Schematics Document Mut il-Media Board

ver: 1.0

Version Change List (P. I. R. List) for Multimedia Board Circuit

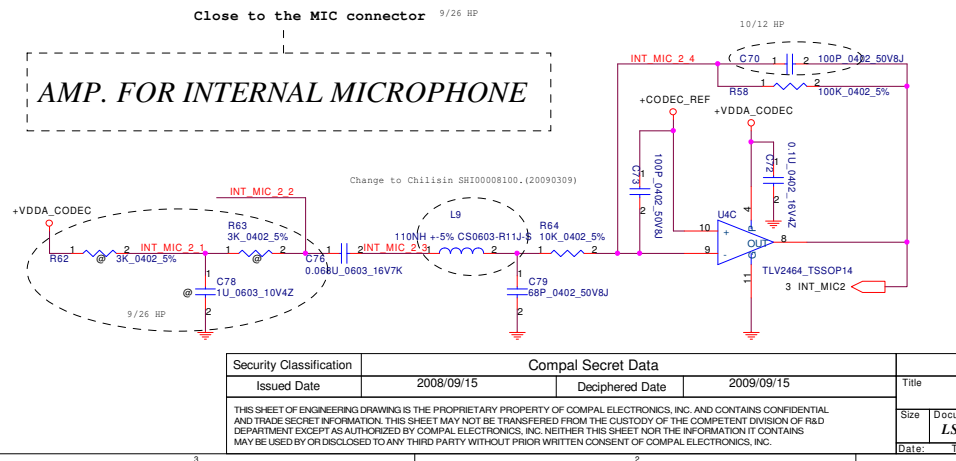
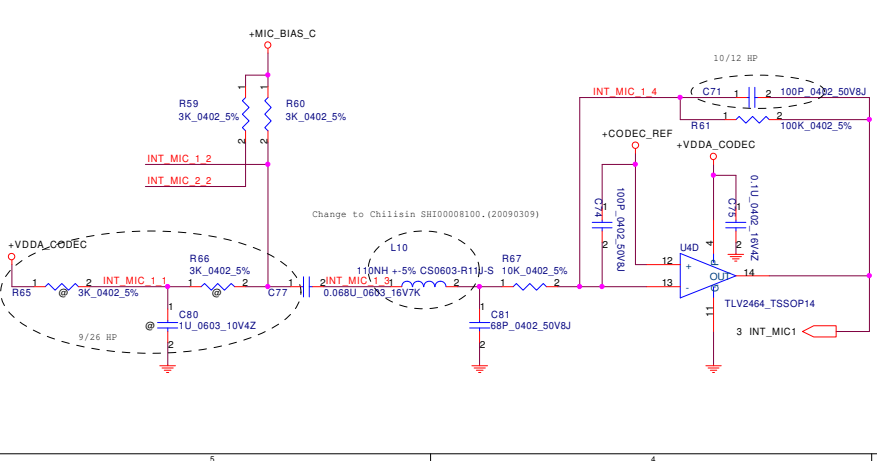
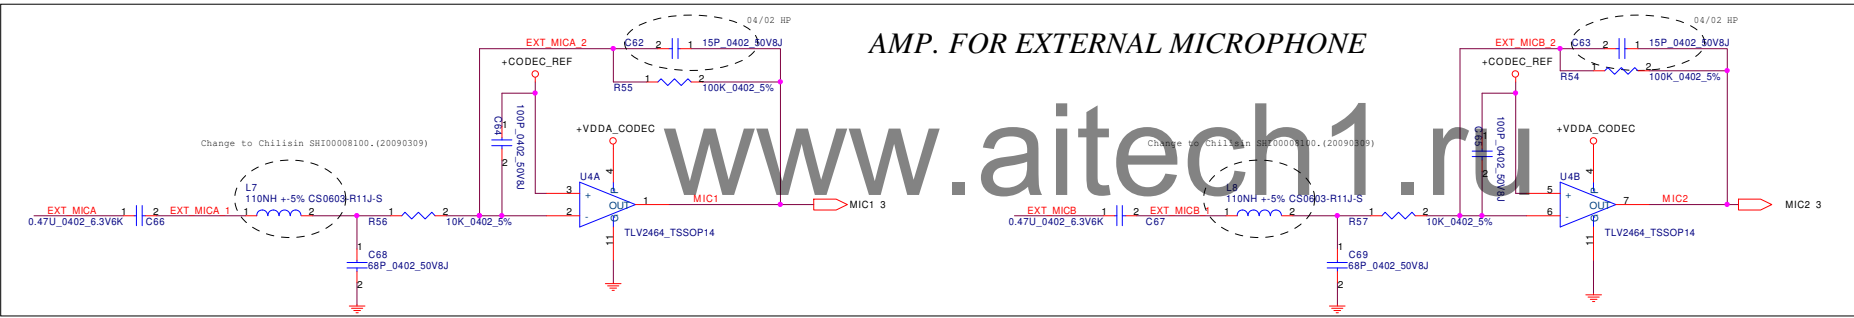
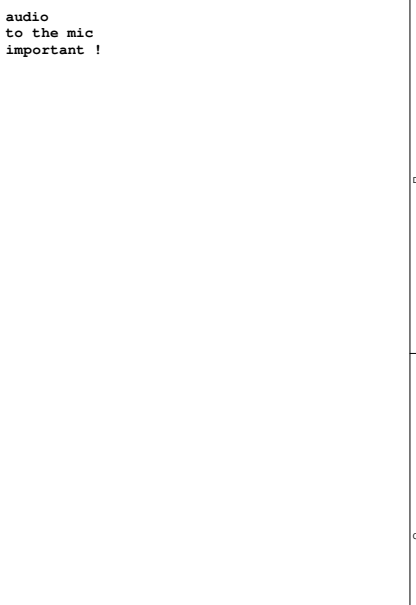
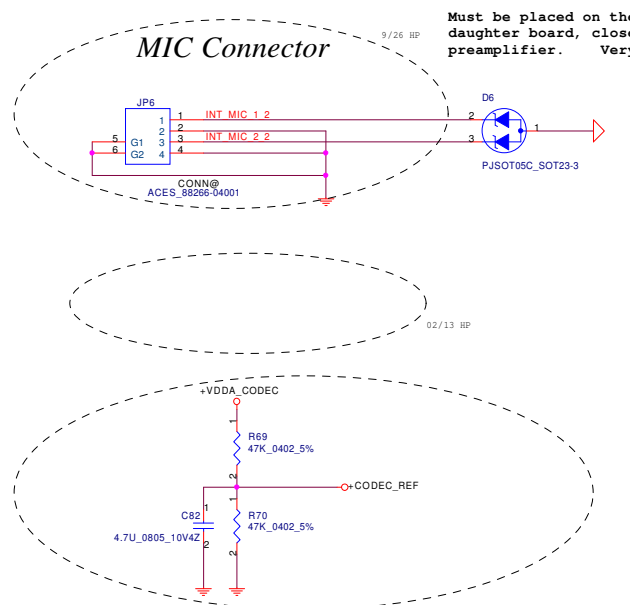
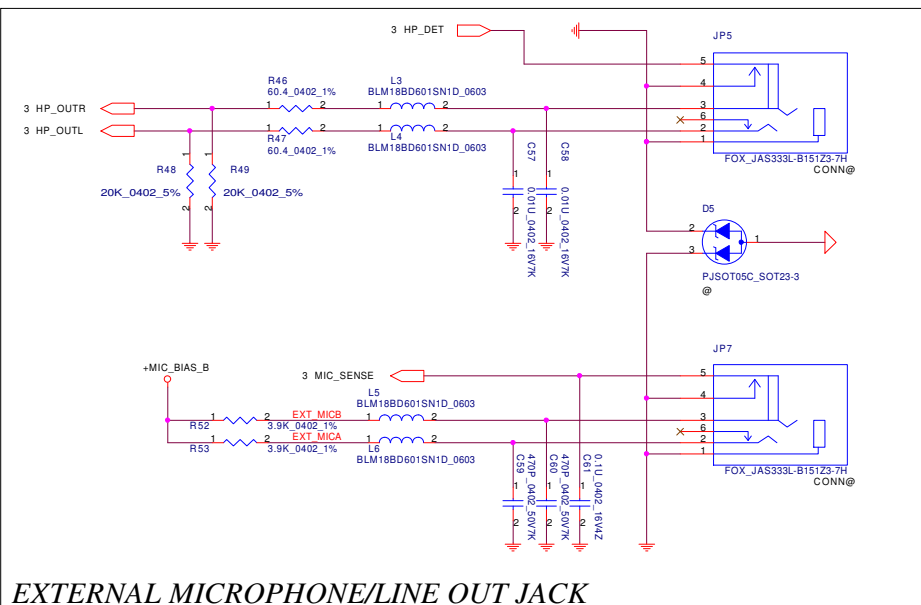
Item	Page#	Title	Date	Request Owner	Issue Description	Solution Description	Rev.
1	3	Audio	11/12	HP	HP request	Modify net name from DOCK_HPS# to LINE_OUT_SENSE.	
2	3	Audio	11/12	HP	HP request	Invert signal with a 2N7002 at R45 for HP request .	
3	3	Audio	11/12	Compal	Chipset can't work normally.	Reverse pin 1 & pin3 on U3.	
4	3	Audio	11/24	Compal	Microphone can't be detected.	Add 10K ohm for pull up to +VDDA_CODEC for MIC_SENSE.	
5	2	Touch Pad	12/12	Compal	TP FFC ME design can not meet pin assignment	change JP2 pin assignment (reverse)	
6	2		12/16	HP	Stub Line effect	Add R78~R81 & RP1 to control 14' BTB connector co-layout.	
7	3		12/29	Compal	Speaker haven't output but docking have output	R76 and R77 change to 100k ohm and pull down to GND	
8	3		1/7	HP	HP request	HDA_RST#_CODEC add a 0.01u cap connect to GND. (Reserve) HDA_RST#_CODEC add a 4.7K ohm pull up to DVDD. (Reserve)	
9	4		1/15	Compal	ESD request	add D6 for Microphone to protect ESD.	0.3

10	3	Audio Amp	02/10	IDT	Codec Analog In/Out port trace crossover.	Change value of C21 & C24 from 2.2uF 0603 10V to 2.2uF 0805 10V.	0.3
11	1	Express Power Switch	02/13	HP	CPPE# and CPUSB# reversed of power switch	Reverse pin 9 and pin 10 of U1.	0.3
12	4		02/13	HP	remove the +V_AMP circuit	Remove R50 and R51	0.3
13	3		03/30		static noise at cold boot heard	Change U2 pin 25 REG_EN to +5VS and reserve D7	0.3
16	4		03/30		for IDT provide reference schematic	Change R52 and R53 to 3K ohm and change R59 and R60 to 3.9K ohm	0.4
17	2		03/31	HP	HP request	change R68 pin 1 from connect +3VS to connect GND and reserve	0.4
18	2		03/31	HP	HP request	install the R75 with 1K ohm	0.4
19	4		4/2	IDT	fix audio precision fail issue (Magnitude Response fail)	change C62 and C63 form 33P to 15P	0.4
20	3		4/8	HP	HP request	change R83 with 100K ohm change R83.1 form +5VS to PLT_RST#	0.4

Item	Page#	Title	Date	Request Owner	Issue Description	Solution Description	Rev.
21	3		4/8	HP	HP request	change D4 to reserve	0.4
22	3		4/10	HP	HP request	change R83 pin1 to +3VALW and reserve R83	0.4
23	3		4/10	HP	HP request	change D7 pin 1 to PLT_RST# and install D7	0.4
24	3		4/15	HP	HP request	remove the D7 connect to REG_EN and +3VALW ;change R83 pin1 to PLT_RST# with 0 ohm	0.4
25	3		4/29	HP	add solution for Mute the audio of Display port	1. add a N MOS connect to EAPD and A_SD# 2. remove the D4 3. connect U3 pin 30 to MUTE_LED_CTL 4. change JP1 and JP11 pin14 from EAPD to MUTE_LED_CTL	0.4
26	3		5/4	HP	modify circuit for Mute the audio of Display port	1. remove N MOS that connect EAPD and A_SD# 2. add the D4 and pin2 connect to EAPD# , pin3 to A_SD# and pin1 to SPRK_EN 3. change JP1 and JP11 pin12 name from A_SD to A_SD#	0.4
27	2		5/11		for GMT express card power switch power pin	connect the U1 pin4 to pin2 , pin5 to pin3 , pin13 to pin11 , pin14 to pin12 ,	0.4

28	3		5/19		HP request	change R83 from 0 ohm to 100k ohm	0.4
29	3		6/25		HP request	change R33 R35 from 4.7k ohm to 6.04k ohm	0.5
30	3		6/25		HP request	change R34 R36 from 4.7k ohm to 2.0k ohm	0.5
31	3		6/25		HP request	change R20 from 100k ohm to 300k ohm	0.5
32	3		8/26		For Tag pop noise when system restart	U2 pin 25 add the R84 pull up to +5VS reserve the R83	0.6
